STATE OF NORTH CAROLINA  
DEPARTMENT OF TRANSPORTATION

SUBJECT: **Request for Modification to the Section 404 Individual Permit and Section 401 Water Quality Certification** for the proposed Winston-Salem Northern Beltway Eastern Section from US 158 to I-40 Bus/US 421, Forsyth County, Division 9. WBS Element No. 34839.1.2, TIP No. U-2579B.

REFERENCE: USACE Individual Permit Action ID SAW-2008-03183, dated June 2, 2014.  
NCDWR Project No. 2014-0090, Certification No. 3987, dated April 11, 2014.

PERMIT DRAWING SHEET 61a OF 64

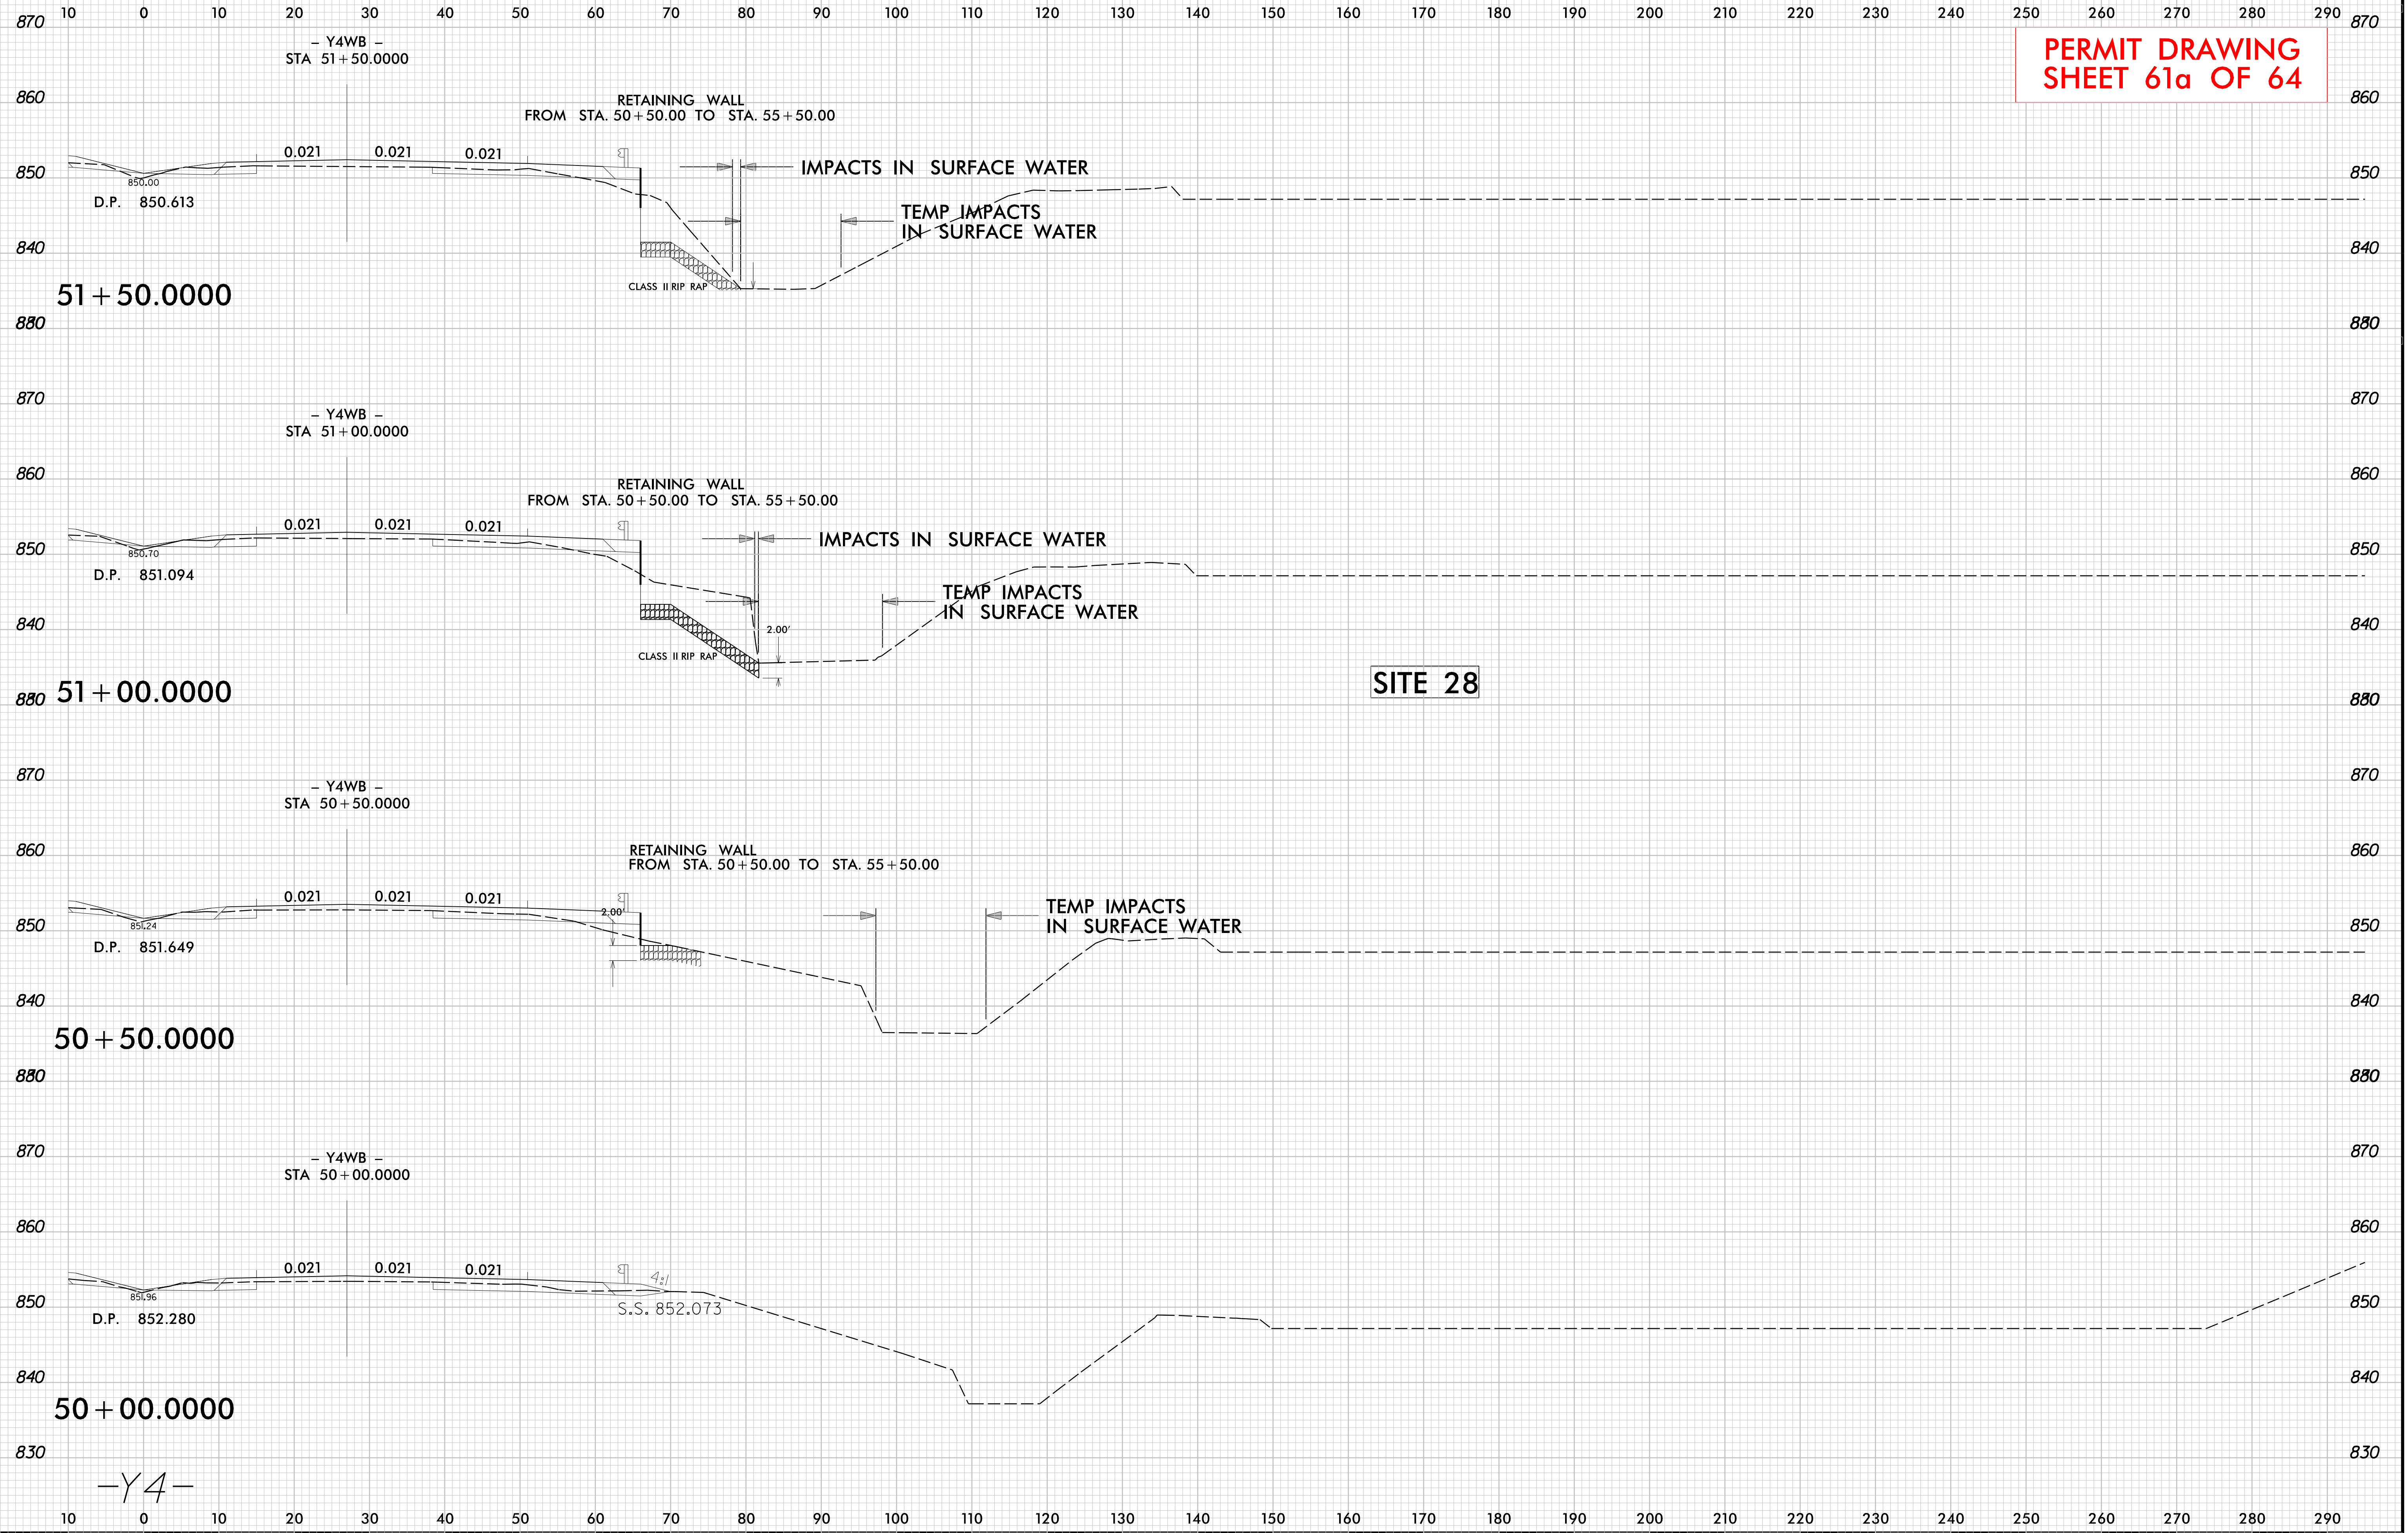
Please replace the current permit drawings with the new revised drawings (Revised Permit Drawing Sheets 2, 3, 38, 39, and 40 of 64) attached with this letter and insert the new Permit Drawing Sheets 61a – 61d of 64 (cross-sections for revised Permit Site 28). Permit Drawing Sheets 2 and 3 were revised due to a non-jurisdictional stream shown as jurisdictional in the original permit application. The revised sheets have removed that feature. No permit sites are affected by this revision.
